Service Bulletin

Title: SB AS350-111014; Airbus AS350 Air Conditioner Aft Evaporator Wiring Harness Blower Motor Connector.

Date: July 6, 2016

Figure 1 AS350-6202 Aft Evaporator Assy

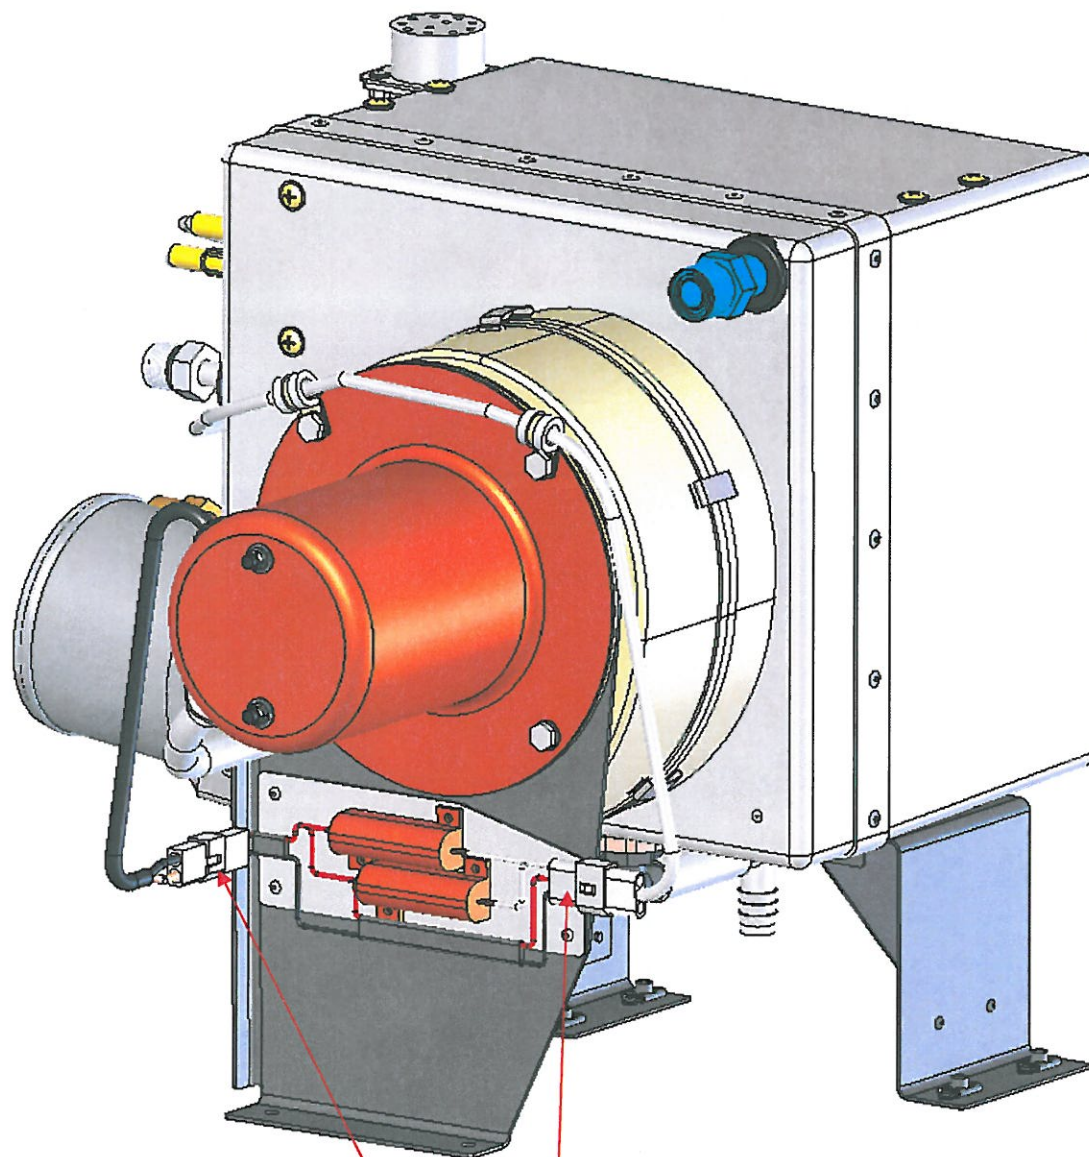
Locate each connector as shown in Figure 1. De-mate each connector and inspect both mates for signs of overheating, discoloration or plastic deformation. Gently pull (estimated 5-7 lb of force) on each wire to verify the integrity of the contact's crimp. The contacts should be fully seated and locked in the housing so pulling gently on the wires will not dislodge the contacts from the housings.

Inspect these connector sets. If replacement is necessary, wire per Figures 2 thru 4

If any signs of overheating of the housing are present or if the pull test fails, the system must be rendered inoperative and the connector housings and contacts replaced with new replacement connectors using Deutsch HDT-48-00 Crimping tool or equivalent MIL-DTL22520 Type 1 crimping tool before further operation. See Section B for information on how to contact Air Comm.
